Advice 5915-E-A

Public Utilities Commission of the State of California

Subject: **Supplemental: Advice Letter Modifying Electric Rule 21 Pursuant to Decision 20-09-035 for Working Group 2 and 3 (due 120 Days from Issuance) for Ordering Paragraphs 5, 6, 8 and 11.**

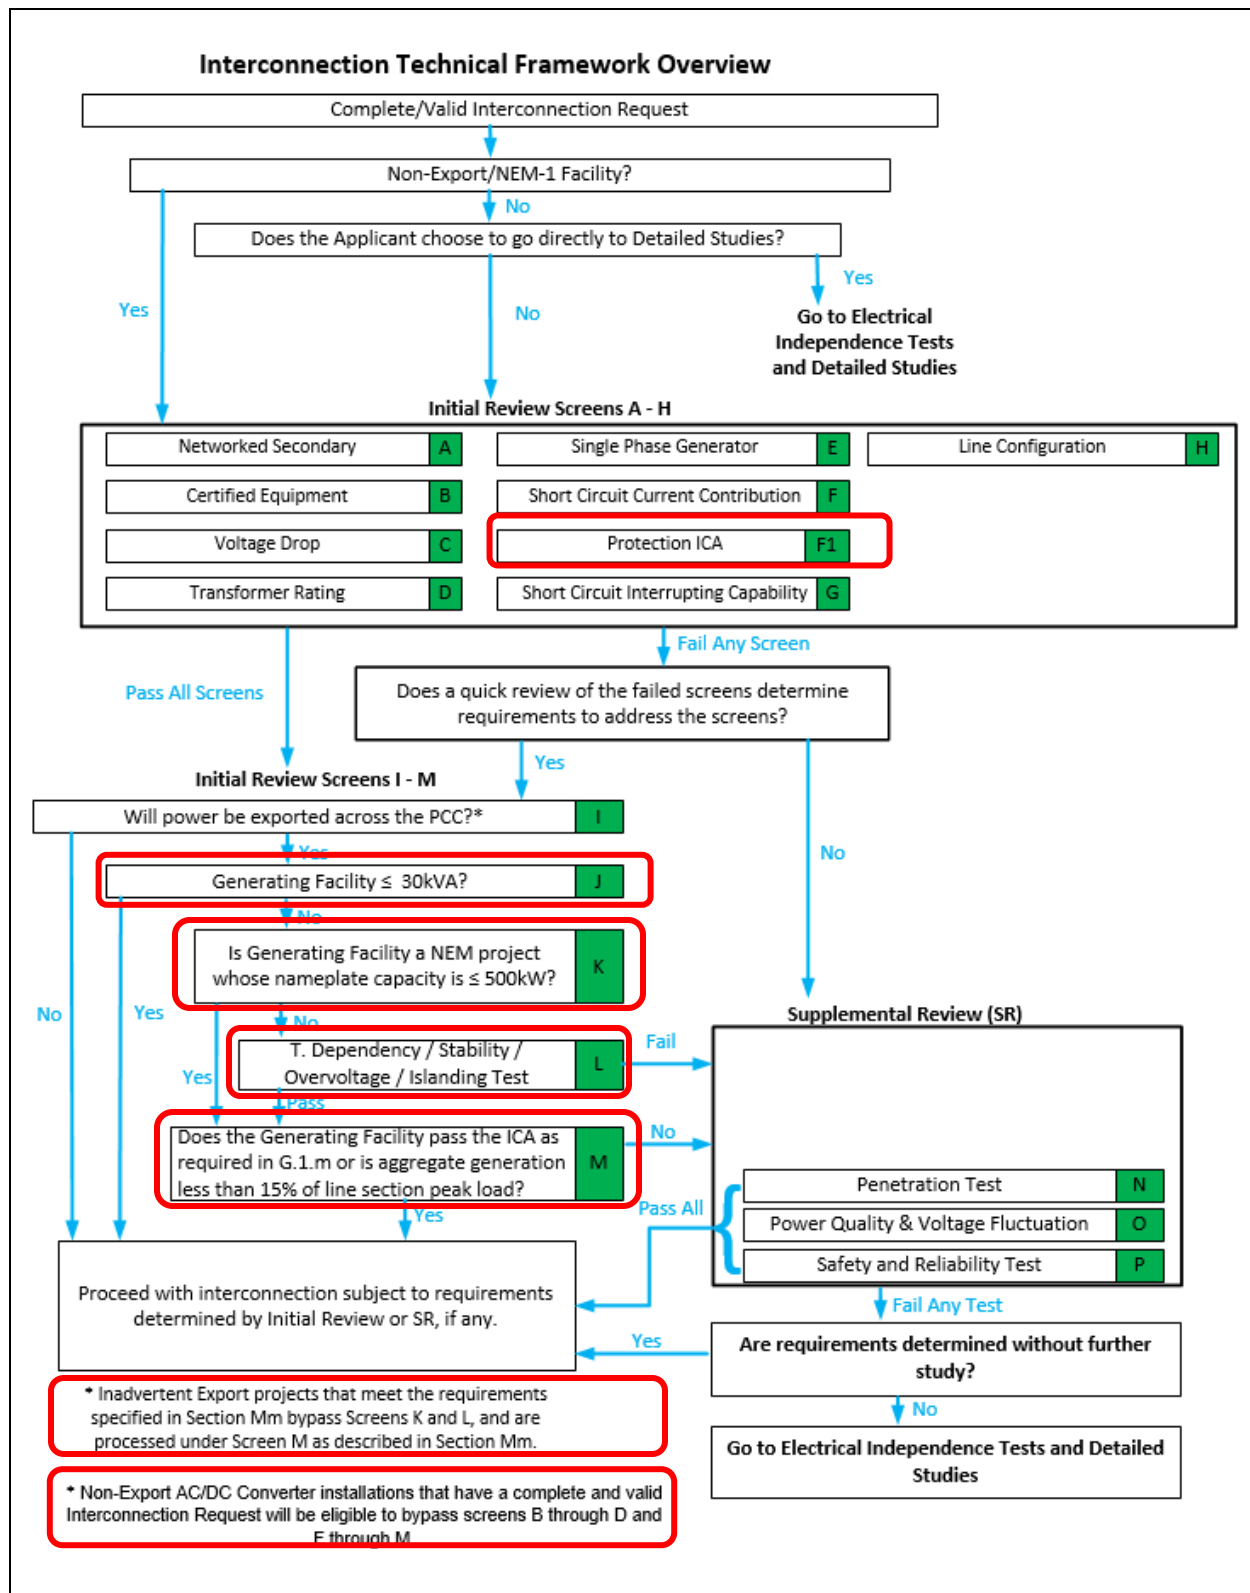
- incorporate Screen F1
- rephrase "Fast Track Eligibility MW Limit" to "Fast Track Request"
- add "Protection ICA" in the Initial Review Screens A-H box
- modify Screen J

PG&E updates the Engineering Review Details flow chart (original sheet 145) consistent with the OP changes above. Additions circled in Red.

Sheet 141

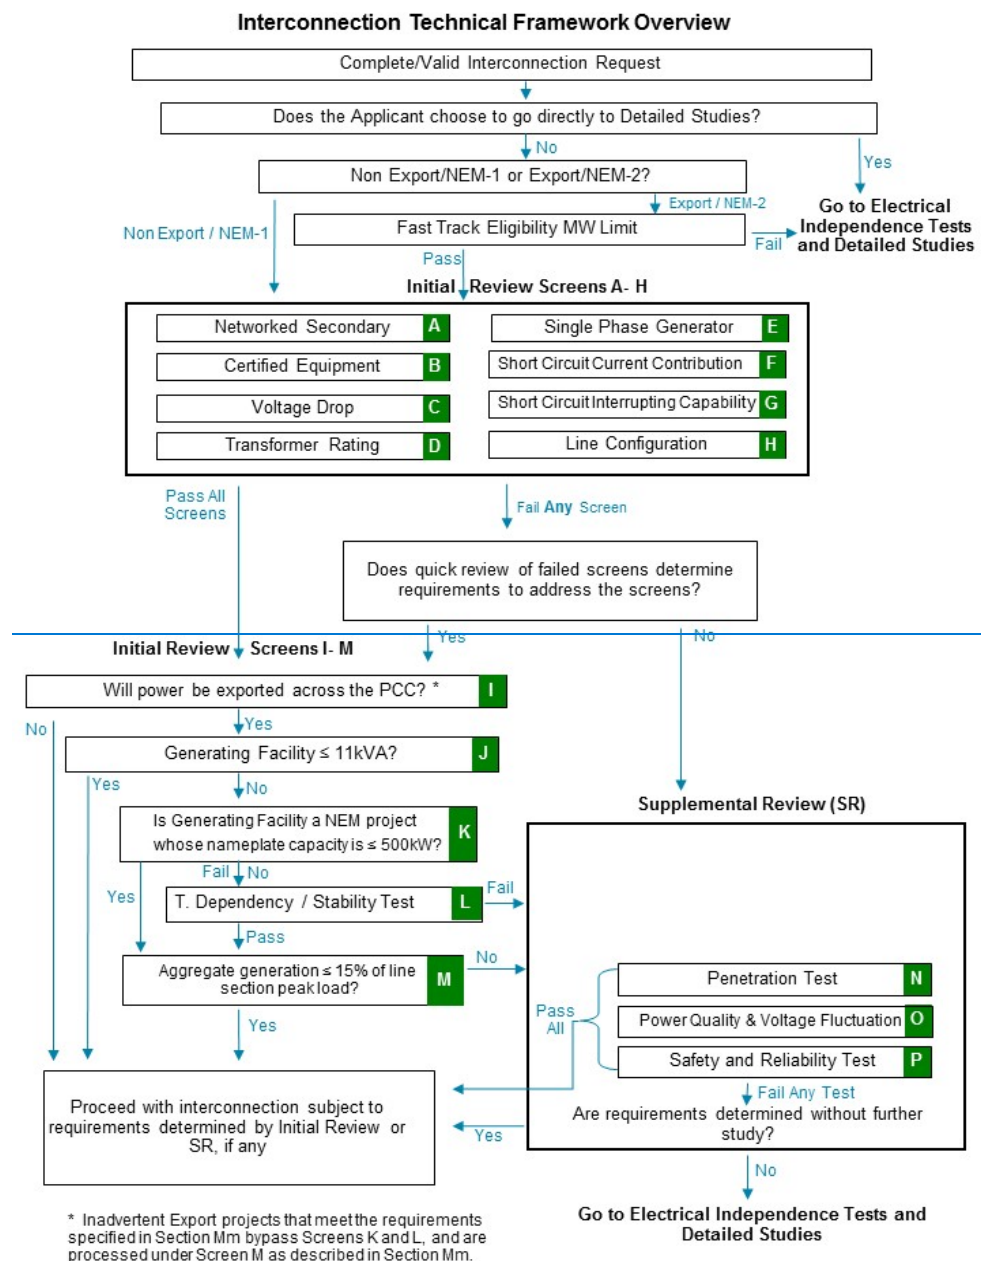
G. ENGINEERING REVIEW DETAILSDelete table below:
